Planning Decisions Committee

6.30pm, Wednesday 15 September 2021

1. This report provides the Planning Decision Committee (PDC) with an assessment of planning permit application PLN20/0950 against the provisions of the Yarra Planning Scheme (the Scheme) and recommends that Council notify the Victorian Civil and Administrative Tribunal (VCAT) and all parties to the proceeding that if Council were in a position to determine the application a Notice of Decision to grant a permit would issue, subject to conditions.

Ward: Langridge Ward
Proposal: Part demolition, construction of an 11 storey mixed use building, use of the land for office/food and drink premises (no permit required and dwellings (permit required) and a reduction of car parking requirements
Existing use: Retail premises (former theatre) and office
Applicant: DPG Management Services Pty Ltd
C/- Contour Consultants Australia Pty Ltd
Zoning / Overlays: Commercial 1 Zone
Design and Development Overlay (Schedule 15)
Environmental Audit Overlay
Heritage Overlay (HO324)
Development Contributions Plan Overlay (Schedule 1)
Special Building Overlay
Date of Application: 23 December 2020
Application Number: PLN20/0950

Image: Extract of south elevation showing new street wall to Johnston Street. Advertised plans (left) and without prejudice sketch plans (right)

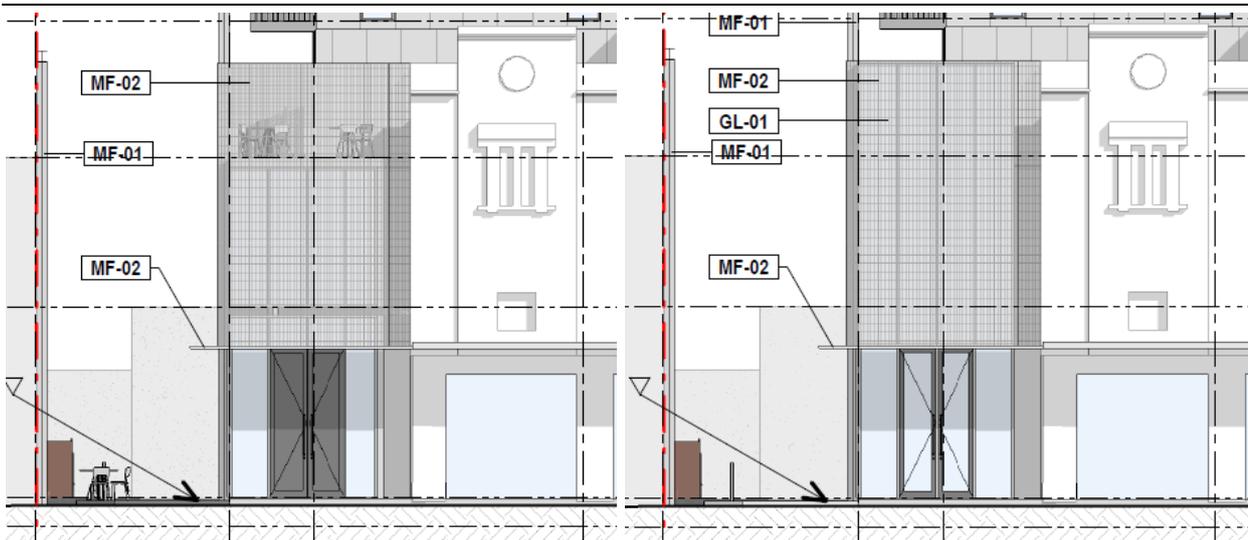
183. A comparison of the infill street wall design on the advertised and sketch plans is shown in the images below.

184. It is considered that the new street wall element to Johnston Street is appropriate and in accordance with the relevant built form requirements of DDO15 given the following:

Image: markup of the advertised west elevation showing the guidelines for 28m height limit, 45 degree angle upper level setback and mid level setbacks (red hatching showing extent of non-compliance).

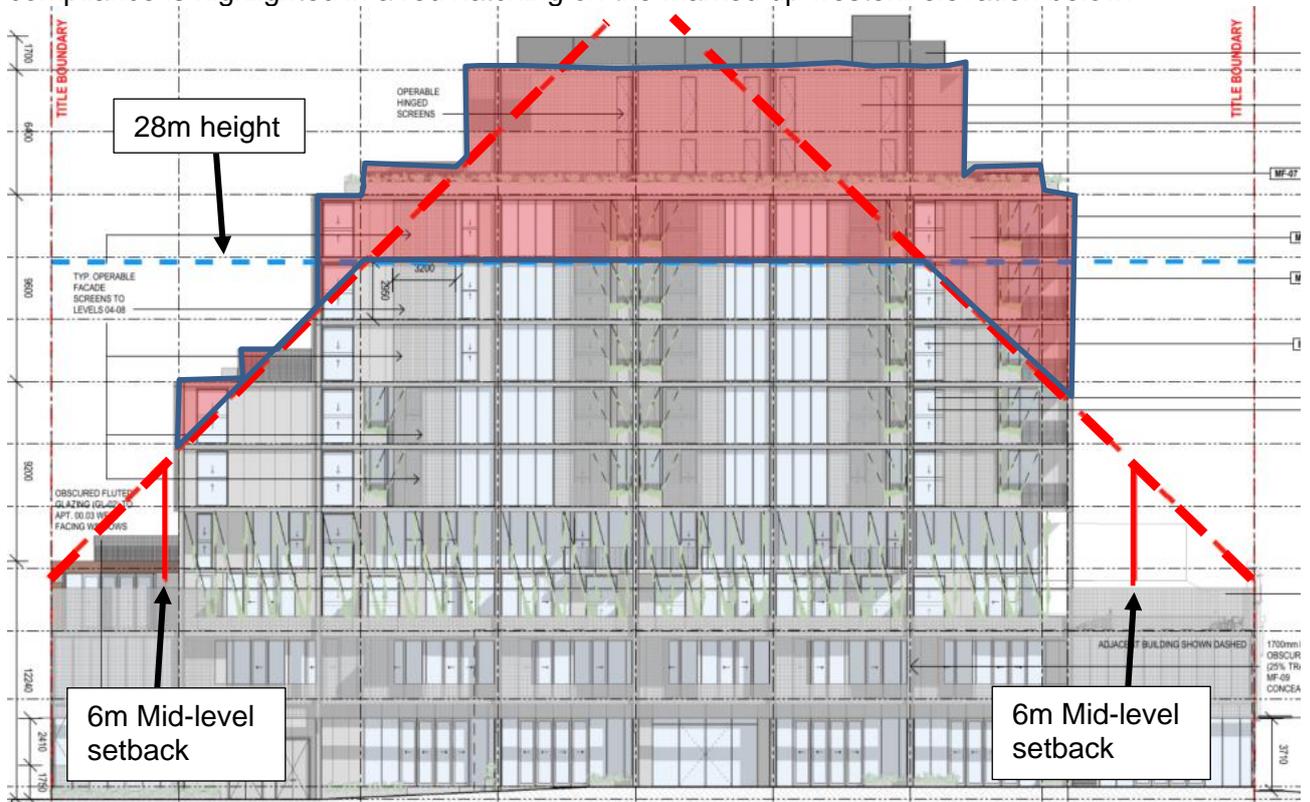
194. As demonstrated above, the proposal meets the mid level setback requirements from both Johnston Street and Sackville Street. Importantly, the mandatory mid level setback requirement from Johnston Street is exceeded by 50%, which is a positive outcome for the extent of heritage fabric to be retained. However, variations from the discretionary building height and upper level setback requirements are required by the proposal. The extent of non-compliance is highlighted in a red hatching on the marked up western elevation below.

195. From a building height perspective, DDO15 states that a permit should not be granted to exceed the preferred maximum building height unless the following criteria are met:

Image: Markup of the without prejudice 'sketch' west elevation showing the guidelines for 28m height limit, 45 degree angle upper level setback and mid level setbacks (red hatching showing extent of non-compliance).

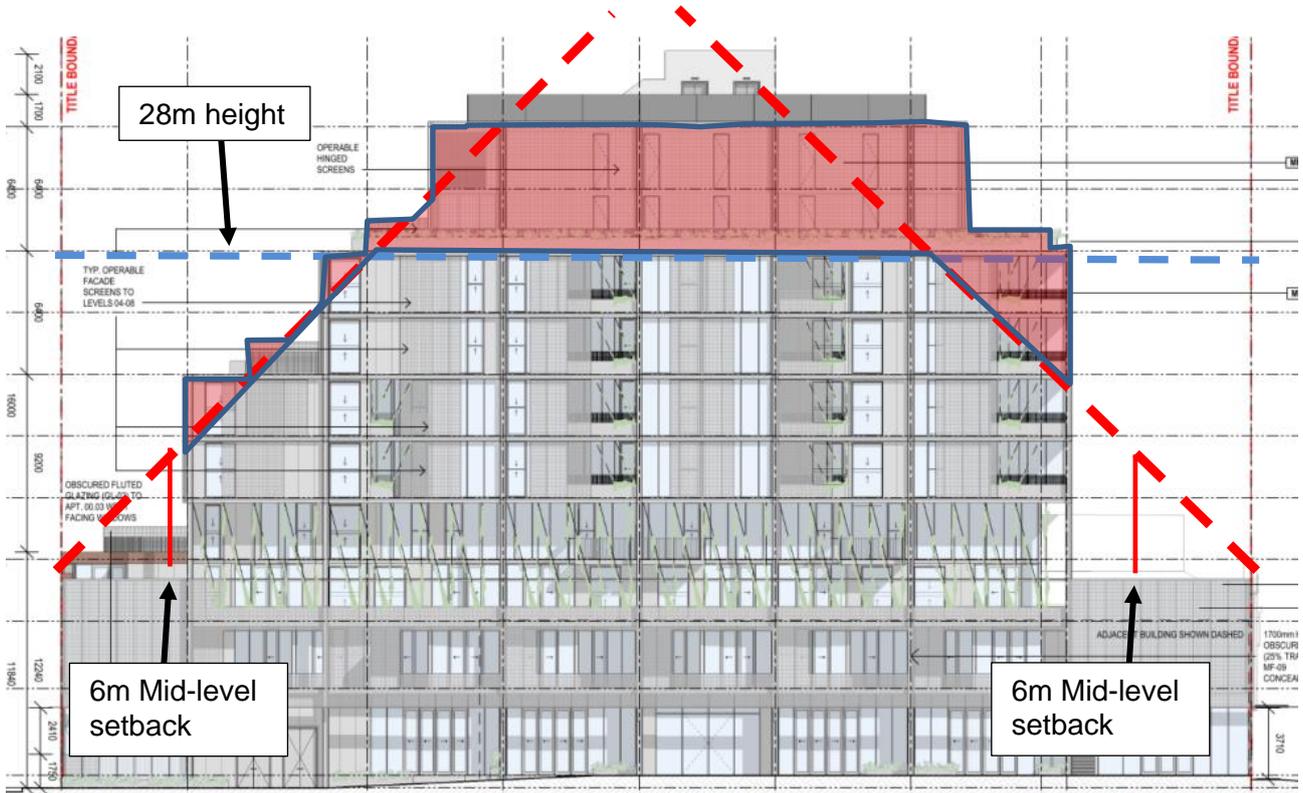
- (b) Decrease of the top two upper levels (now Level 08-09) east and west boundary setbacks by 0.5m (approximately 6.9m to a minimum of 6.4m).
202. The extent of non-compliance with upper level DDO15 requirements is shown in the markup of the west elevation below.

203. The above markup, shows that the extent of non-compliance with DDO15 upper level setback requirements is proposed to be noticeably reduced by the sketch plans. To further assist, the applicant has also included a set of perspective views comparing the visual impacts of the advertised and sketch plans. Comparison views along Johnston Street are provided below.
